UNITED STATES
NUCLEAR REGULATORY COMMISSION
WASHINGTON, D.C. 20555-0001

SUBJECT: SOUTH TEXAS PROJECT, UNITS 1 AND 2 - STAFF ASSESSMENT OF INFORMATION PROVIDED PURSUANT TO TITLE 10 OF THE *CODE OF FEDERAL REGULATIONS* PART 50, SECTION 50.54(f), SEISMIC HAZARD REEVALUATIONS FOR RECOMMENDATION 2.1 OF THE NEAR-TERM TASK FORCE REVIEW OF INSIGHTS FROM THE FUKUSHIMA DAI-ICHI ACCIDENT (TAC NOS. MF3935 AND MF3936)

STAFF ASSESSMENT BY THE OFFICE OF NUCLEAR REACTOR REGULATION

SOUTH TEXAS PROJECT, UNITS 1 AND 2

Figure 3.2-1 Plot of Staff's and Licensee's Base Rock Mean Hazard Curves at a Variety of Frequencies for the South Texas Project site

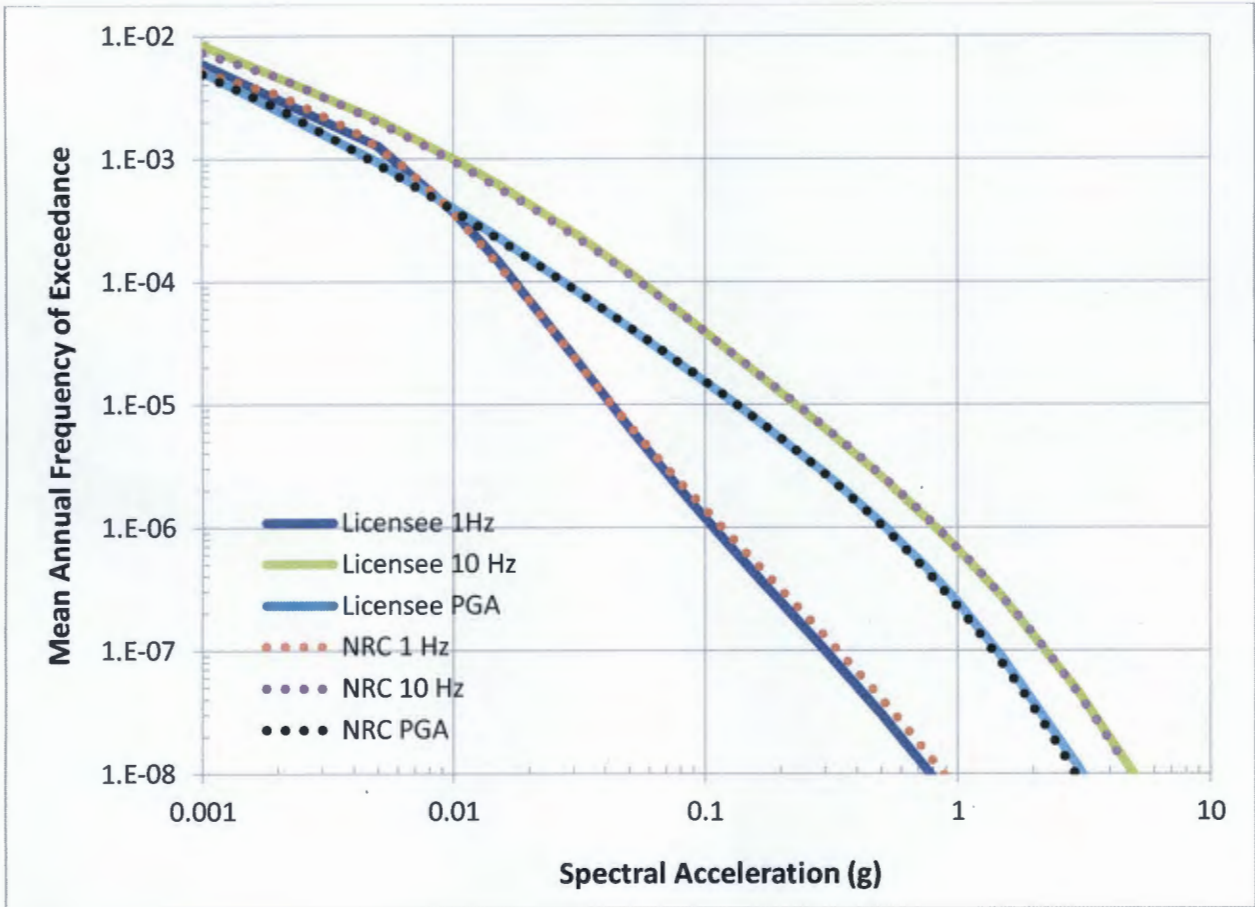
Figure 3.2-1 of this assessment shows a comparison of the licensee's and the staff's base rock seismic hazard curves at 1, 10, and 100 (PGA) Hz. As shown in Figure 3.2-1, the licensee's and the NRC staff's base rock hazard curves are similar, which indicates that differences in licensee's and staff's PSHA inputs had little impact on the results.

Figure 3.3-1 Plot of Staff's and Licensee's Base Case Shear-Wave Velocity Profiles for the South Texas Project site

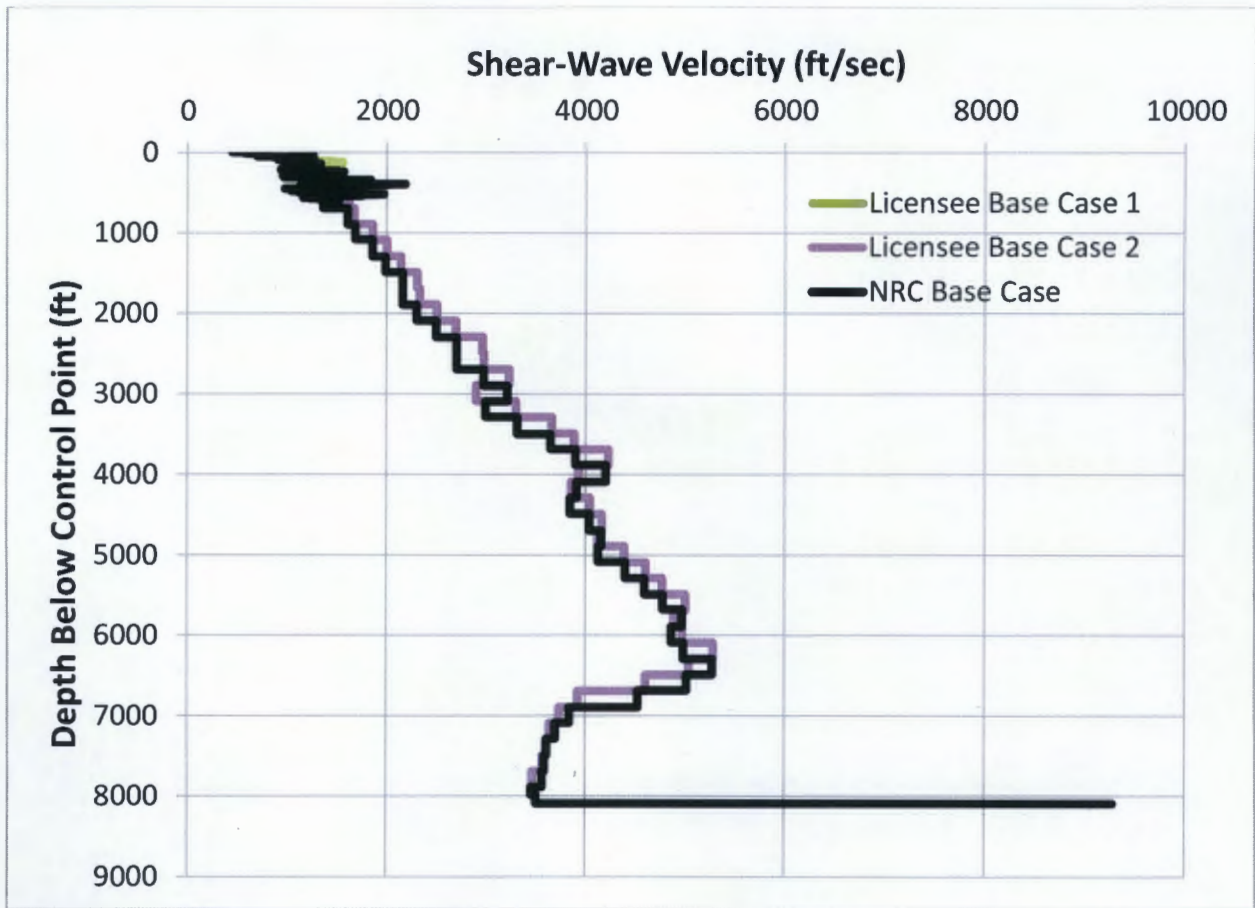
Because the site is well characterized and the velocities reported in the UFSAR for STP, Units 1 and 2 and proposed STP, Units 3 and 4 are similar, the NRC staff used only a single shear wave velocity profile rather than the two profiles used by the licensee. For the depth interval between the control point and the base of the profile, the NRC staff used the shear-wave velocity profiles in the FSAR for the proposed STP, Units 3 and 4 (STP, 2014). This profile is based on the recent data collected at the STP site and is consistent with data from the STP Units 1 and 2 UFSAR (STP, 2010), indicating that the site is relatively uniform. Figure 3.3-1 of this assessment shows the NRC staff velocity profile compared to the base case profiles developed by the licensee.

Figure 3.3-1 Plot Comparing the Staff's and the Licensee's Median Amplification Functions and Uncertainties for the South Texas Project site

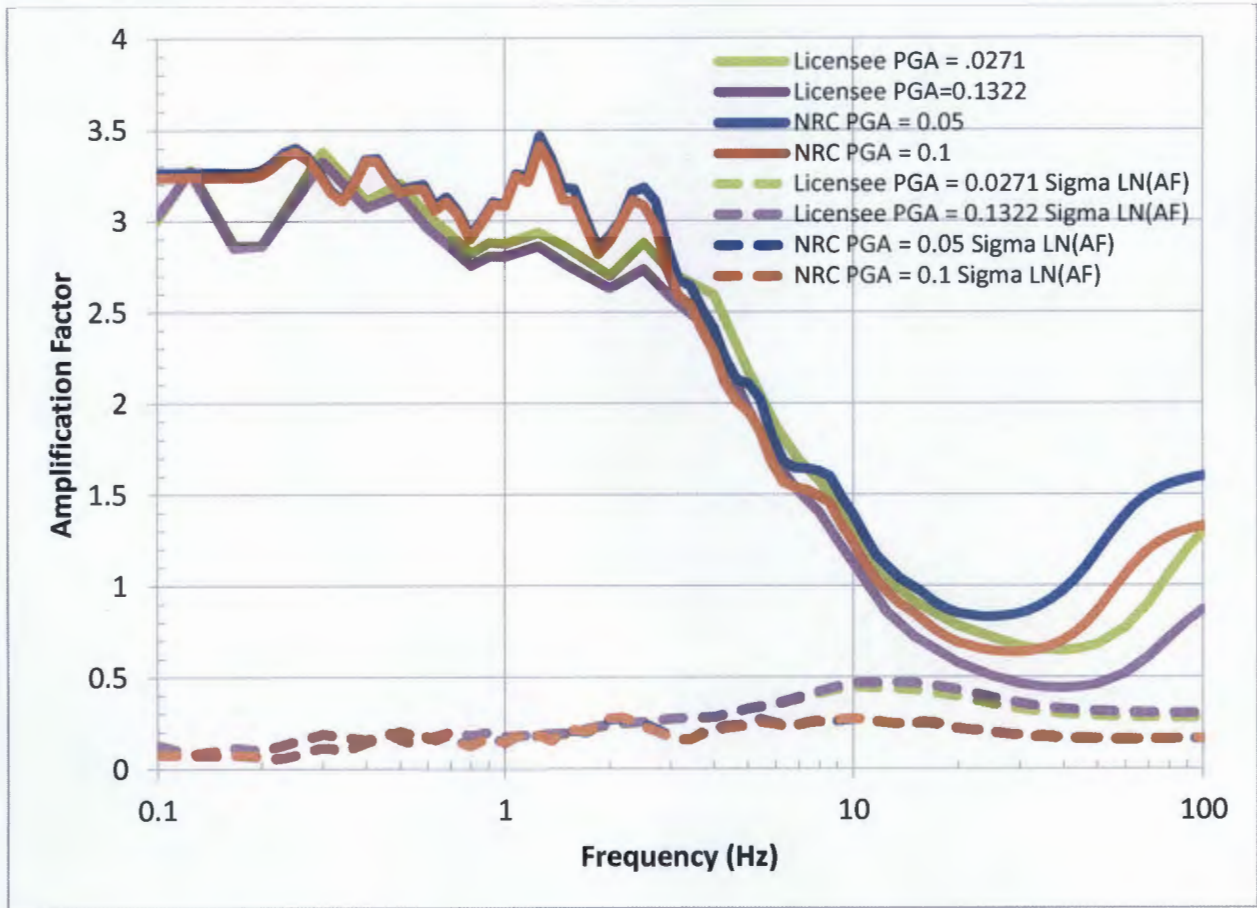
Figure 3.3-2 of this assessment shows a comparison of the licensee's and NRC staff's median site amplification functions and uncertainties (± 1 standard deviation) for two input loading levels. Amplification functions developed by the NRC staff are generally higher than those developed by the licensee across the frequency range of interest. However, these differences are small and do not substantially effect the hazard results as shown below in Figure 3.3-3, which shows the licensee's and staff's control point hazard curves for STP.

Figure 3.4-1 Comparison of the Staff's GMRS with Licensee's GMRS and the SSE for the South Texas Project site

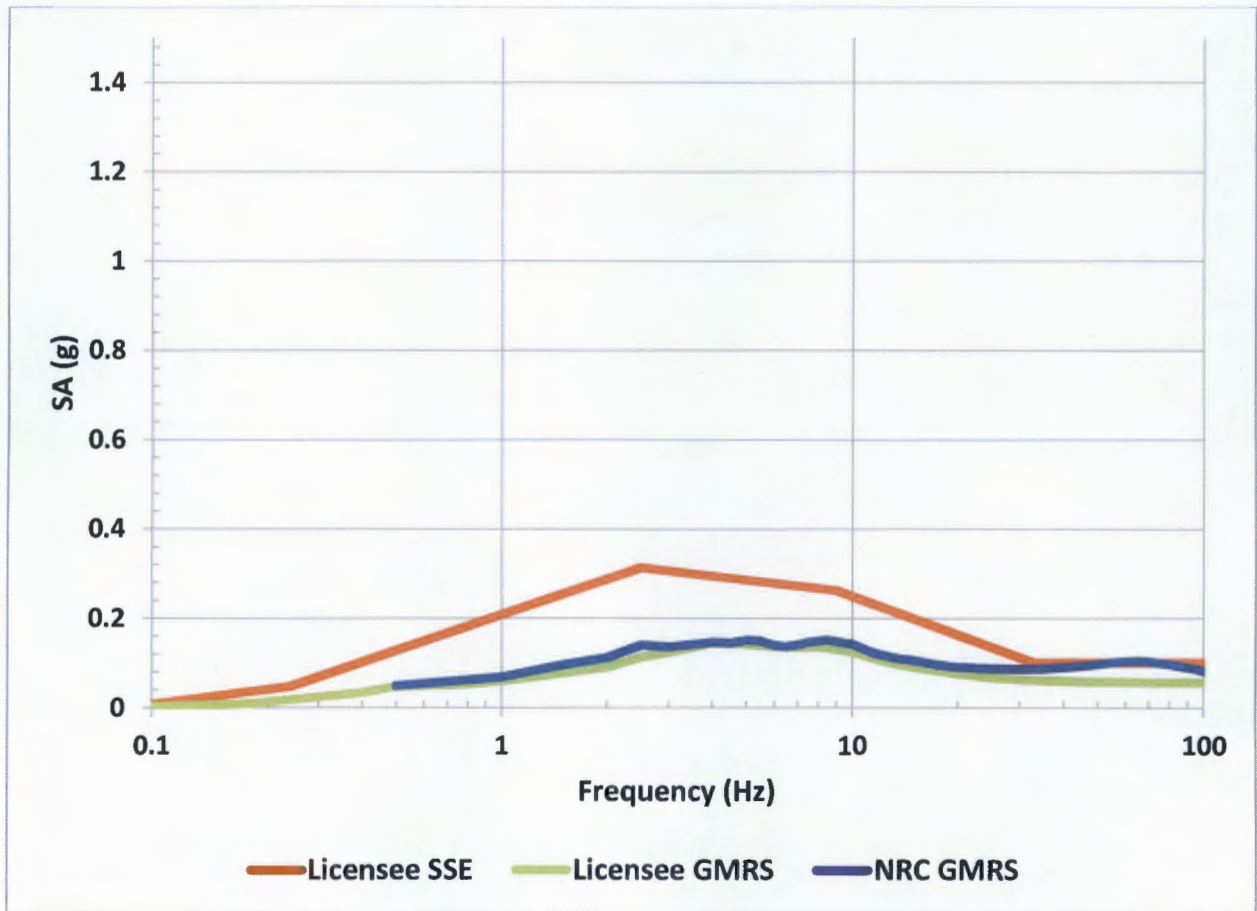
The NRC staff independently calculated the 10^{-4} and 10^{-5} UHRS using the results of its confirmatory PSHA and site response analysis, as described in Sections 3.2 and 3.3 of this staff assessment, respectively. Figure 3.4-1 of this assessment shows a comparison of the GMRS

determined by the licensee to that determined by the NRC staff. As shown in Figure 3.4-1, the licensee's GMRS shape is very similar to that calculated by the NRC staff.

The NRC staff confirms that the licensee used the present-day guidance and methodology outlined in RG 1.208 and the SPID to calculate the horizontal GMRS, as requested in the 50.54(f) letter. The NRC staff performed both a PSHA and site response confirmatory analysis and achieved results consistent with the licensee's horizontal GMRS. As such, the staff concludes that the GMRS determined by the licensee adequately characterizes the reevaluated hazard for the STP site.
